CTC MEETING # 22
December 1 – 2, 2011
CTC Elevator Lobby Study Group & CTC # 22 NOTES

TOPICS ADDRESSED BY PROPOSALS

PROPOSAL 4

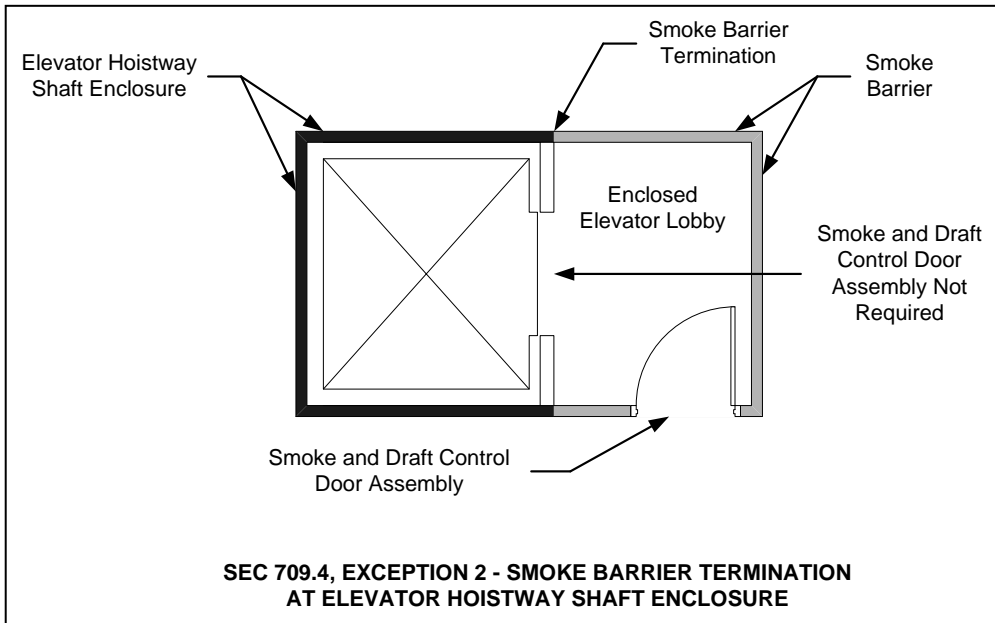
709.4 Continuity. *Smoke barriers* shall form an effective membrane continuous from outside wall to outside wall and from the top of the foundation or floor/ceiling assembly below to the underside of the floor or roof sheathing, deck or slab above, including continuity through concealed spaces, such as those found above suspended ceilings, and interstitial structural and mechanical spaces. The supporting construction shall be protected to afford the required *fire-resistance rating* of the wall or floor supported in buildings of other than Type IIB, IIIB or VB construction.

Reason: Provisions are necessary to clarify that opening protection at the hoistway opening is not necessary when an enclosed elevator lobby is provided in accordance with Section 405.4.3, 3007.7.2, or 3008.7.2. An enclosed elevator lobby protects the hoistway from smoke migration, therefore the hoistway is already protected. In addition the shaft walls provide sufficient smoke and draft protection to allow the smoke barriers to terminate at those walls.

PROPOSAL 6

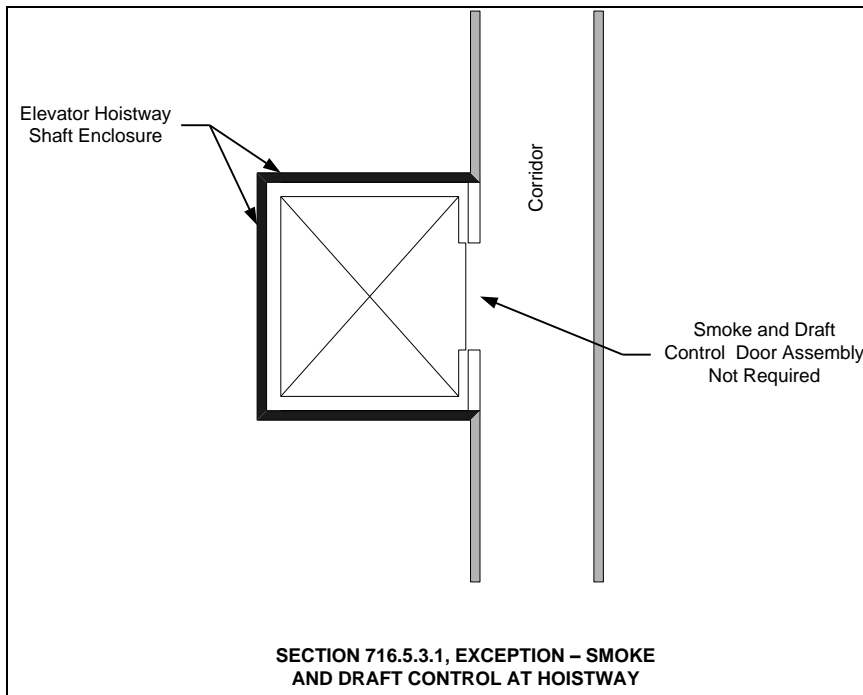
716.5.3.1 Smoke and draft control. *Fire door* assemblies shall also meet the requirements for a smoke and draft control door assembly tested in accordance with UL 1784. The air leakage rate of the door assembly shall not exceed 3.0 cubic feet per minute per square foot ($0.01524 \text{ m}^3/\text{s} \cdot \text{m}^2$) of door opening at 0.10 inch (24.9 Pa) of water for both the ambient temperature and elevated temperature tests. Louvers shall be prohibited. Installation of smoke doors shall be in accordance with NFPA 105.

Exception: Where enclosed elevator lobbies are not required by Section 713.14.1, elevator hoistway doors opening into a corridor are not required to meet the requirements for a smoke and draft control door assembly.

Reason: This proposal is intended to clarify that when an elevator lobby is not required in accordance with Section 713.14.1 that smoke and draft protection is not required when the hoistway opens into a rated corridor. See figure below. Section 713.14.1 is based upon number of stories and not the fact that such elevators open onto a rated corridor so it is not entirely clear how the code is currently written that this was the intent. The following are the sections that are relevant to this issue and which demonstrate how such confusion could occur. The lobby provisions are independent from the corridor provisions.
